REGIONAL REVIEW FINDING

ARC REVIEW CODE: R2008071

Name of Proposal: GT Technology Enterprise Park (DRI #3131)

Description: A Development of Regional Impact (DRI) review of a proposed project to build a mixed-use project at Georgia Tech Technology Enterprise Park, located at the southeast corner of Northside Drive (US 41/SR 3) and North Avenue (US 29/SR 8) in the City of Atlanta. The project proposes 610,000 SF of industrial space, 1 million SF of office space, 100,000 SF of commercial space, and 416 multifamily apartment units. The local trigger is a rezoning from I-1 and I-2 to I-MIX. Expected buildout is 2029.

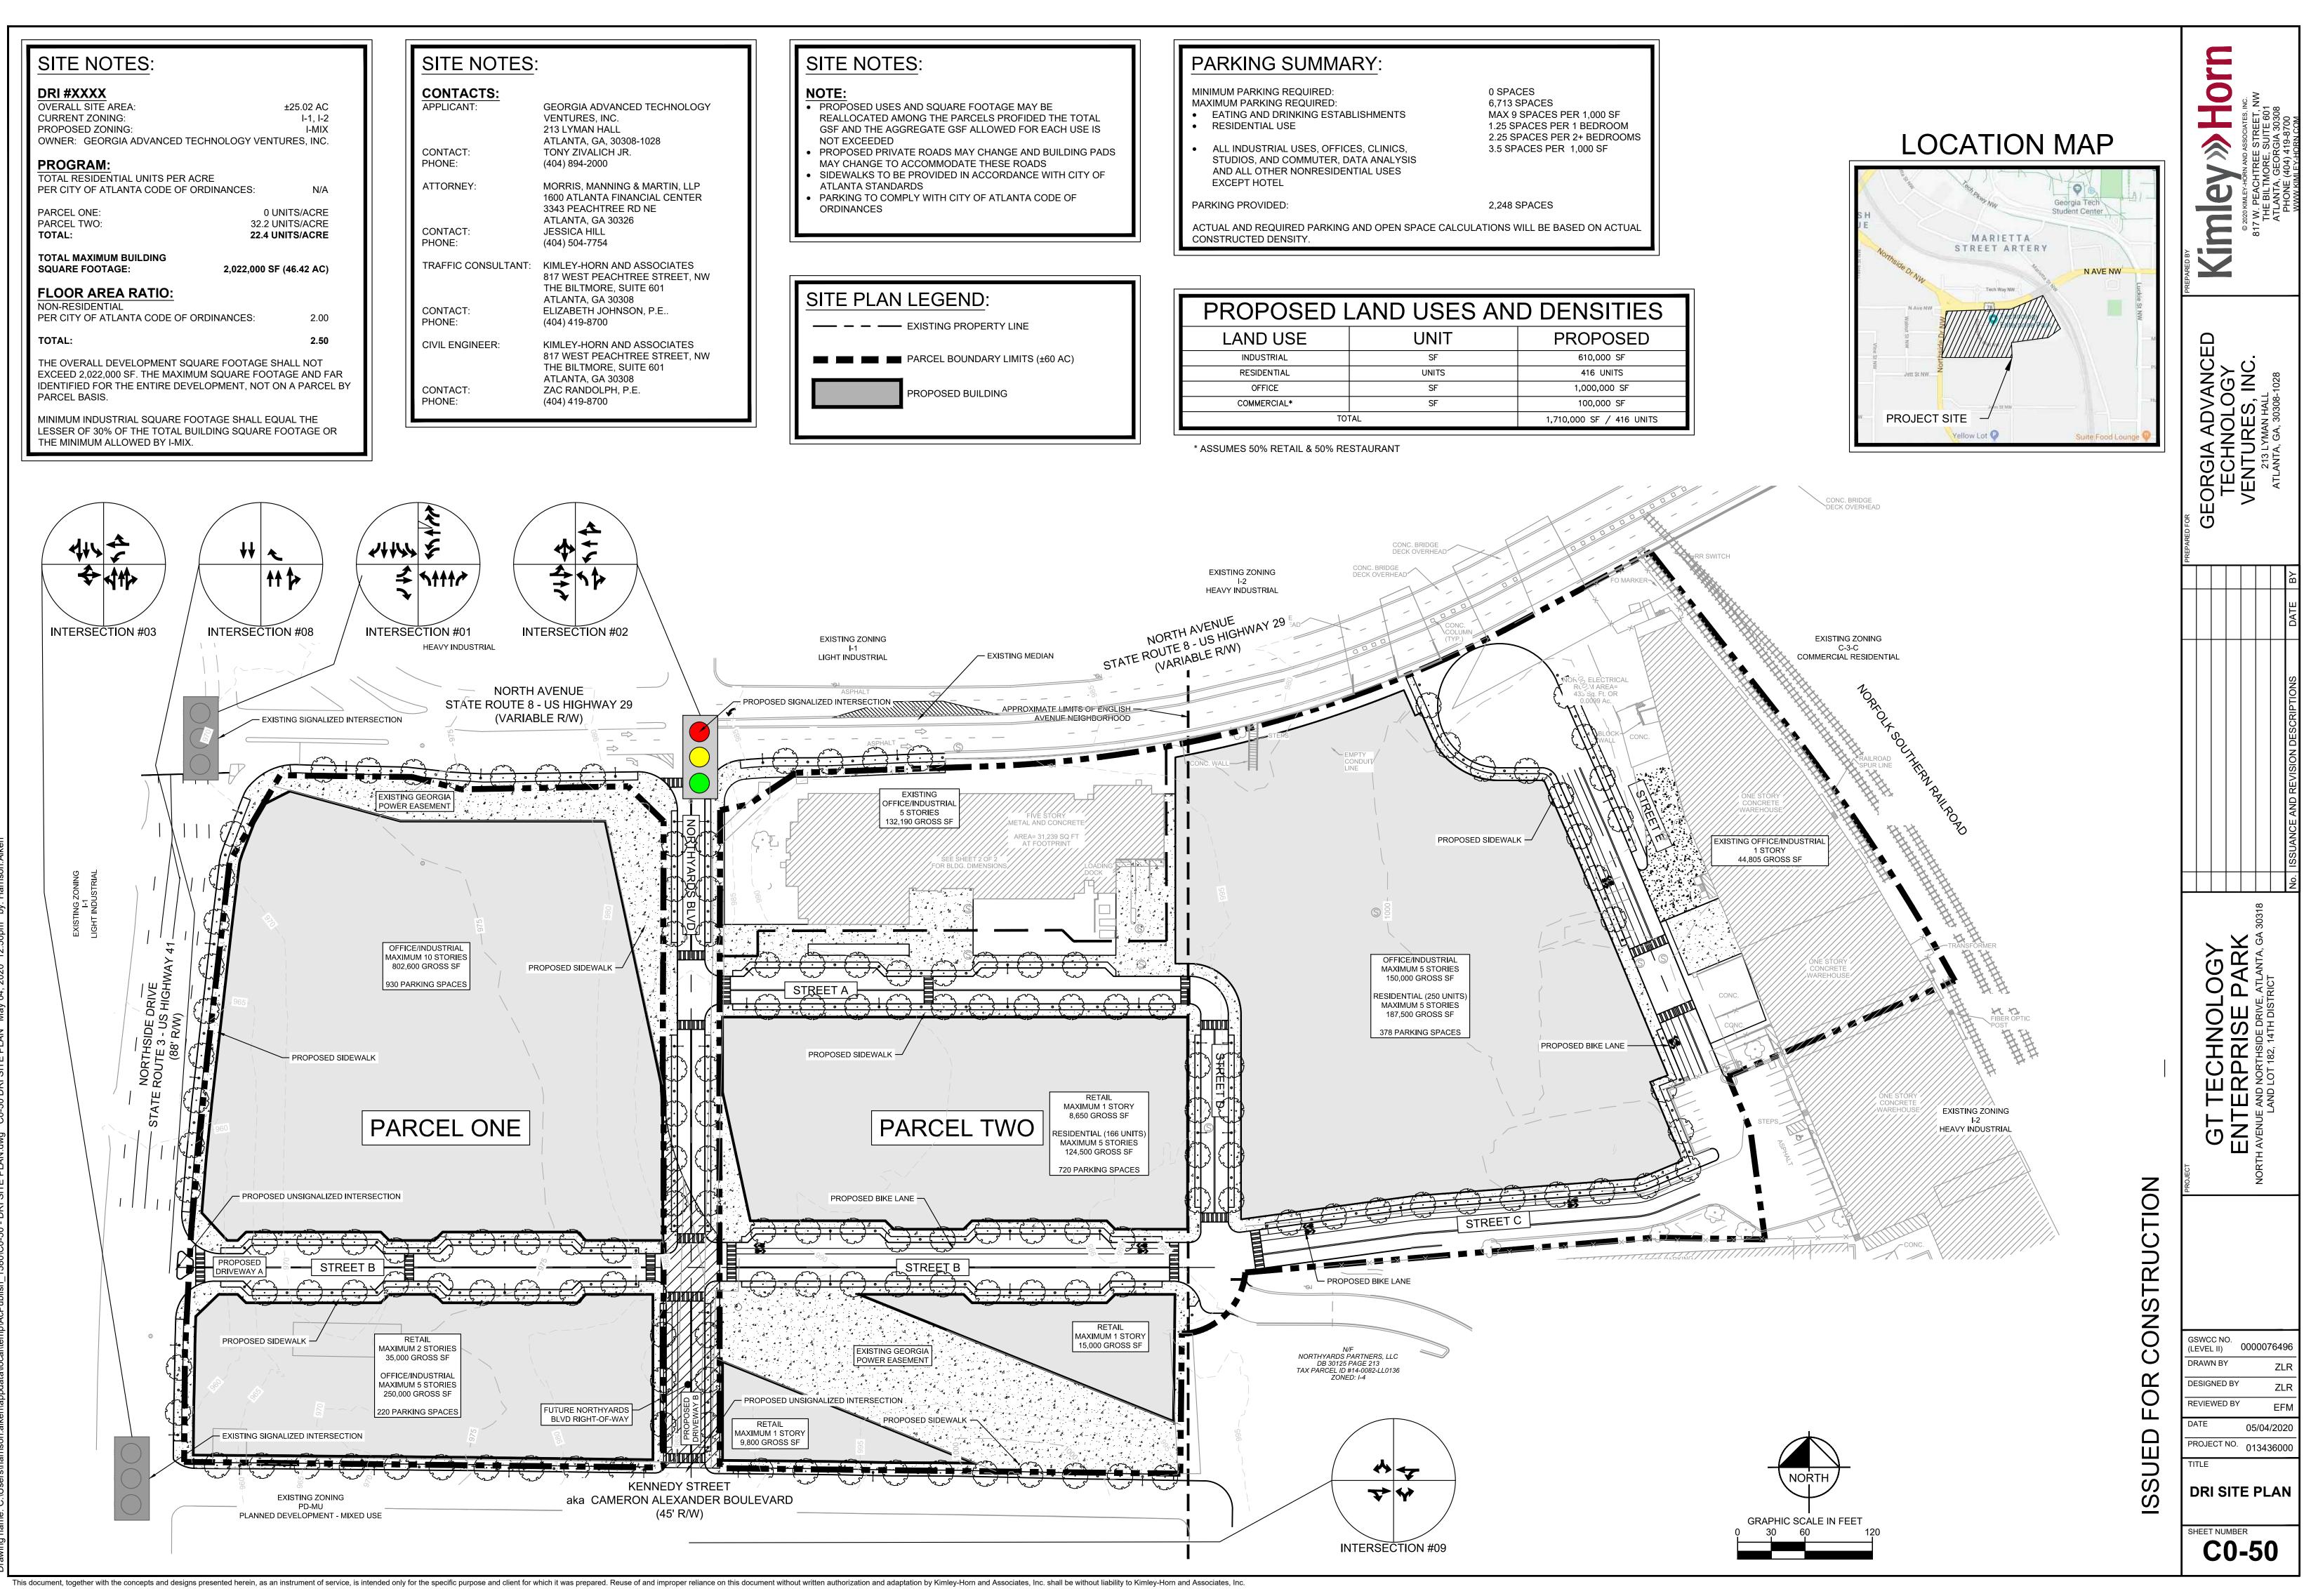
As of this writing, the submitted site plan only depicts building "envelopes," with basic uses, density, and number of parking spaces on each parcel within the development. Pedestrian and vehicle entrances are not indicated, which makes it difficult to understand internal site circulation. It does not indicate locations of transit and ride-hailing services in relation to the various uses. Bike facilities are shown on some of the internal streets, but it's not clear whether there is a larger plan to facilitate alternative modes. The two-way cycletrack depicted on Streets B, C, and E is not an accepted roadway configuration for bike facilities by most standards, unless it is protected with no parking on the side. It would be preferable to implement aggressive traffic calming with shared space on all interior streets rather than a mix of shared streets and separated facilities. Attention to alternative modes is all the more important considering the likely tenant mix for all uses will include students, many of whom don't own or use personal automobiles. Bike racks and spaces for shared mobility options, such as bike-share and scooters, should be clearly identified and logically placed throughout the site. It will also be critical to provide reliable shuttle service to the site as part of the Georgia Tech system, but this will require a funding partnership between the development entity and the shuttle service, which is funded by student fees.

Traffic analysis states that between 1000 – 1500 parking spaces provided while site plan shows over 2000.
